SITE PLAN
 SCALE 1" = 10'
 3705 11TH PL. SE
 MERCER ISLAND, WA 98040
 PARCEL #5458800550
 ZONING: R-8.4

A NEW HOME FOR:
 THE LIU RESIDENCE
 3705 11TH PL. SE
 MERCER ISLAND, WA 98040

JOB NO: 21006
 DATE: 6/13/22
 DRWN. BY: TH
 REVISED: 9/8/22
 6/1/23
 8/16/23
 9/20/23

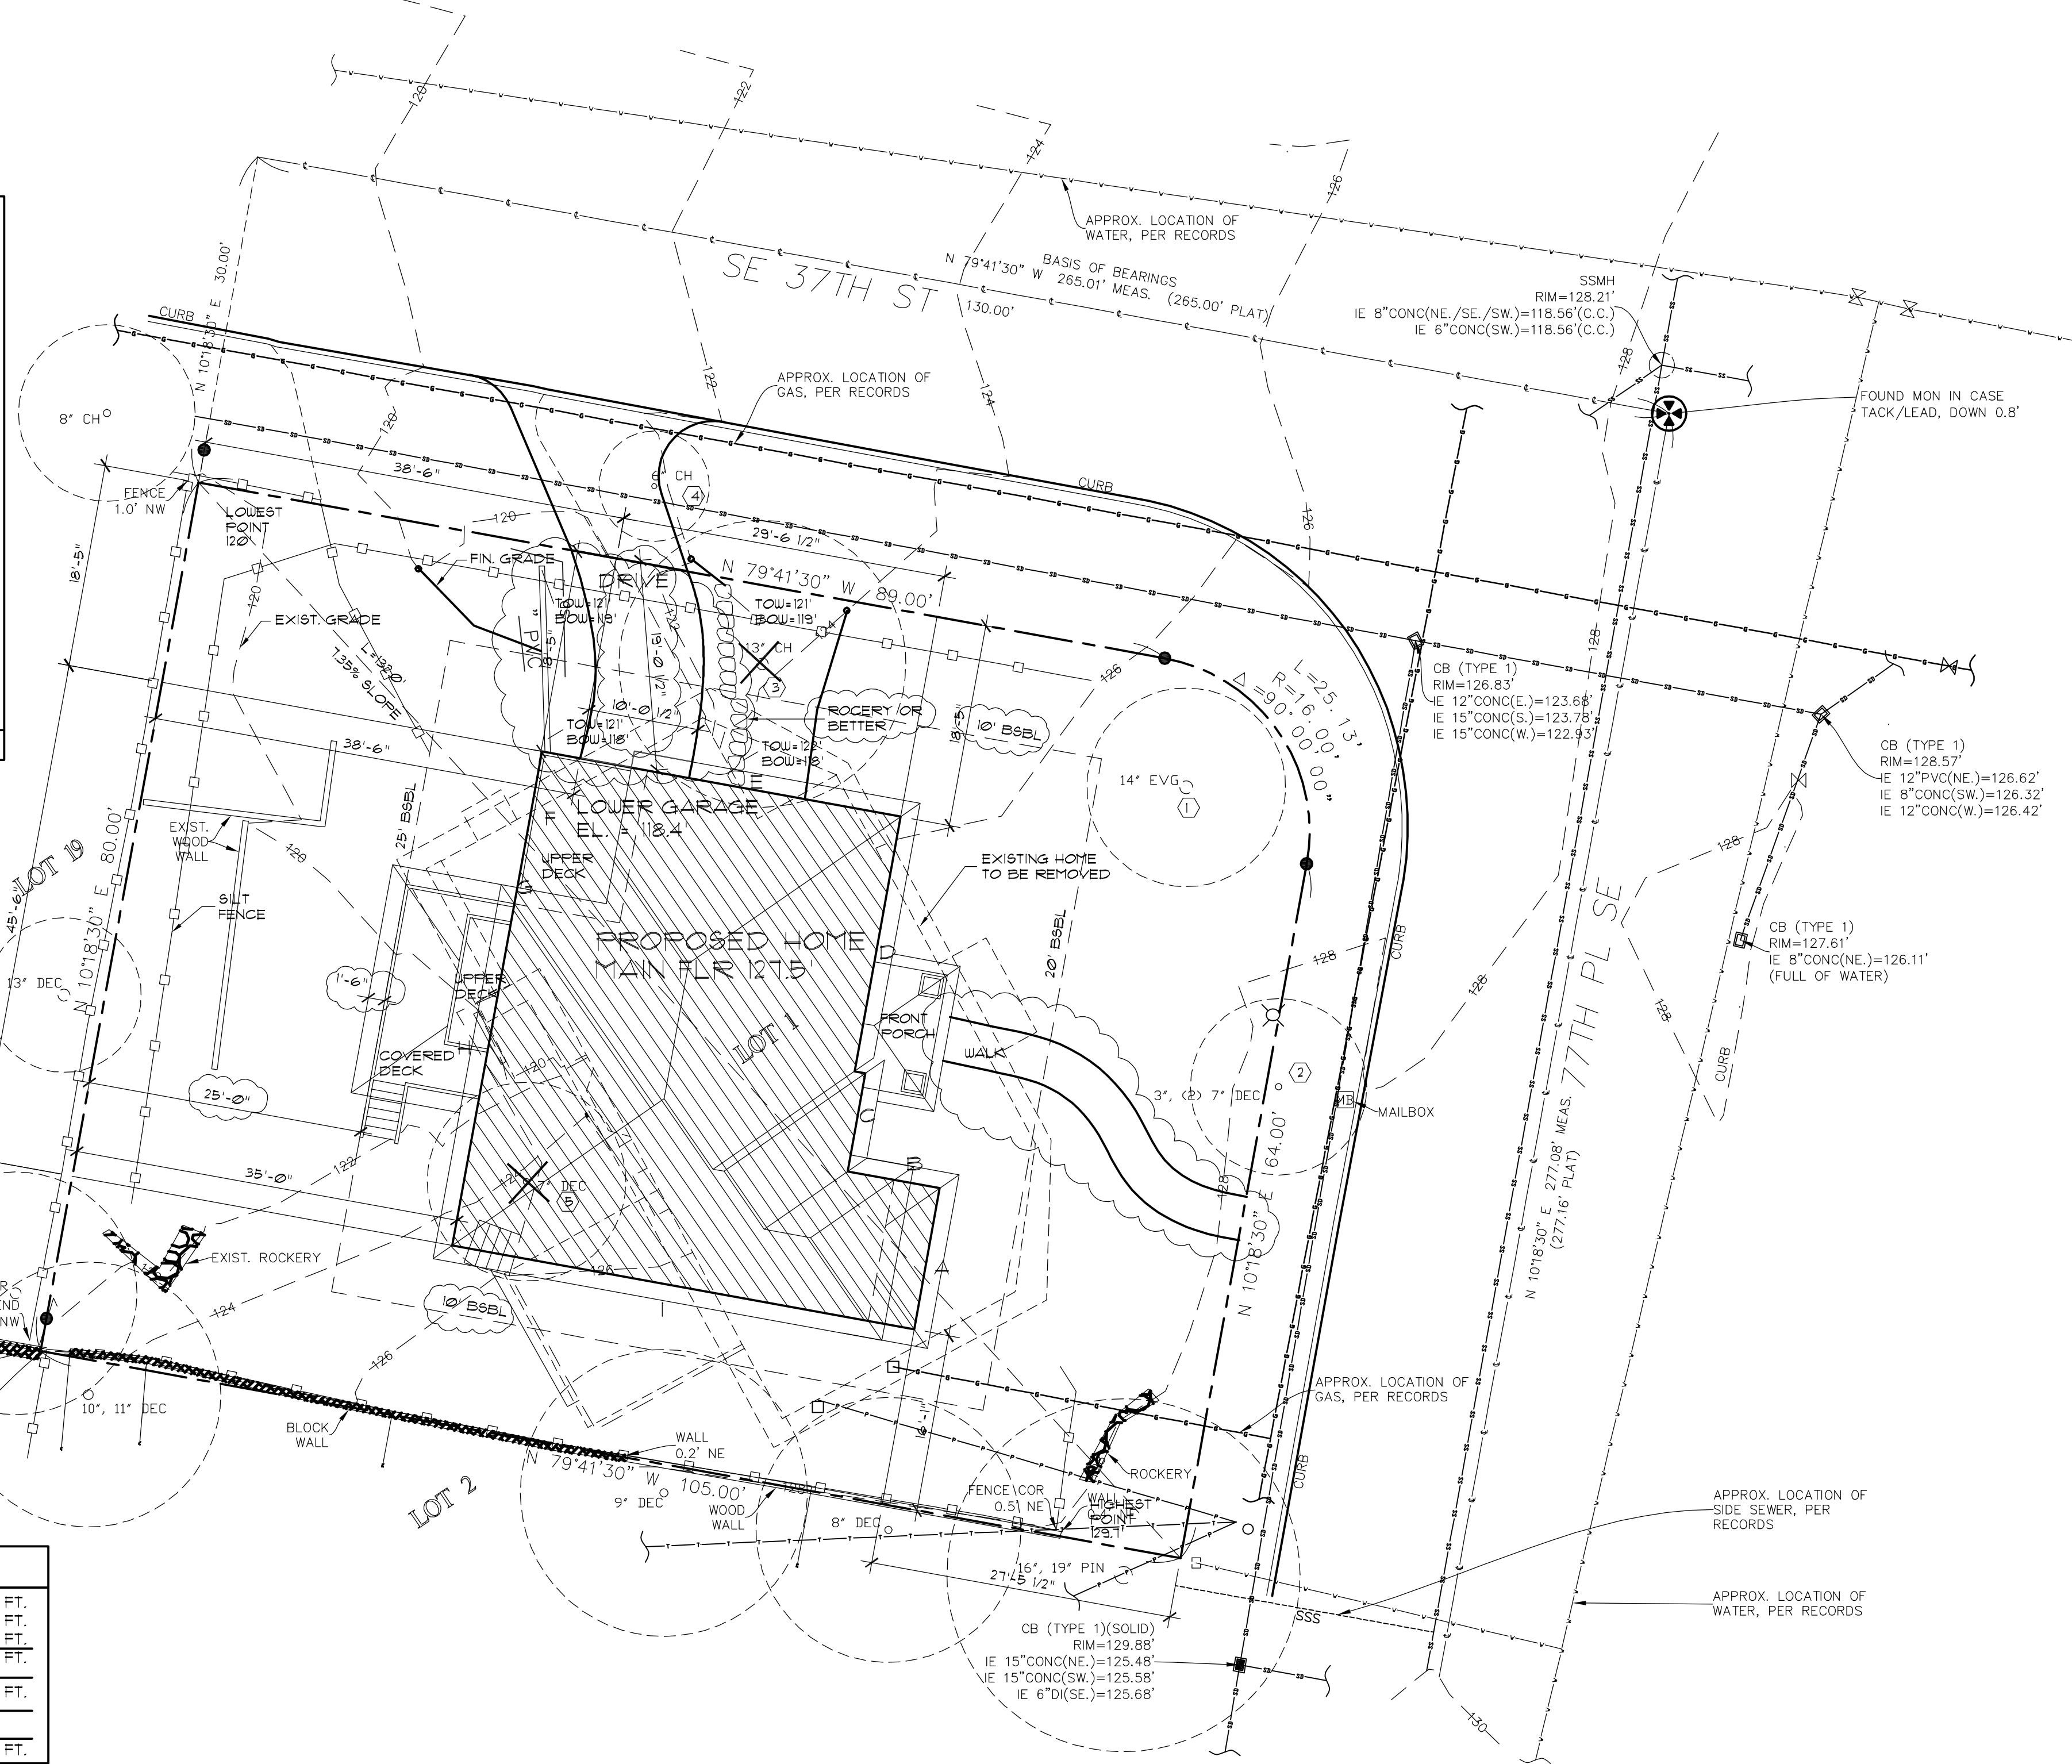
MICC 19.02.020(F)(3)(d) requires noxious weeds to be removed during new development proposals. Please add a note to the plan set that states:

"Development proposals for a new single-family home shall remove Japanese knotweed (*Polygonum cuspidatum*) and Regulated Class A, Regulated Class B, and Regulated Class C weeds identified on the King County Noxious Weed list, as amended, from required landscaping areas established pursuant to subsection 19.02.020(F)(3)(a). New landscaping associated with new single-family home shall not incorporate any weeds identified on the King County Noxious Weed list, as amended. Provided, that removal shall not be required if the removal will result in increased slope instability or risk of landslide or erosion."

Pursuant to MICC 19.02.050(D) any "...rockeries, retaining walls, fences, or any combination thereof, are limited to a maximum height of 42 inches within that portion of any required yard which lies within 20 feet of any improved street." Please indicate the height of the rock wall that falls within 20 feet of the public-right-of-way.

If the height exceeds the 42-inch height limitation you can apply for a fence height deviation pursuant to MICC 19.02.050(F).

Fence height deviation required for 4' retaining walls.
